LMC News Notes

Volume 2, Number 10B

October 1983

Game/Assembly Affected: 19" Color X-Y Monitor (P/N 200-0025-00) E/H G08-003

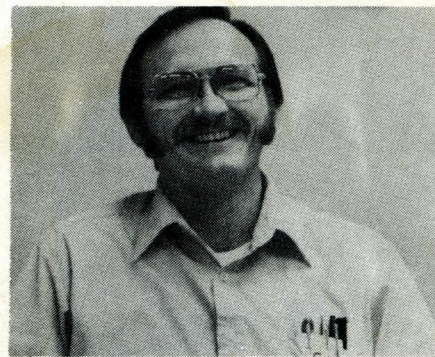
Subject: Deflection Amp PCB; R635 equivalent

Action: A single 3 ohm 20 Watt resistor (P/N 474-0003-00) may be used interchangeably with the existing pair of 1.5 ohm resistors (P/N 474-0150-00) in the event of a failure. The G08-003 Color X-Y Monitor was used in the following games:
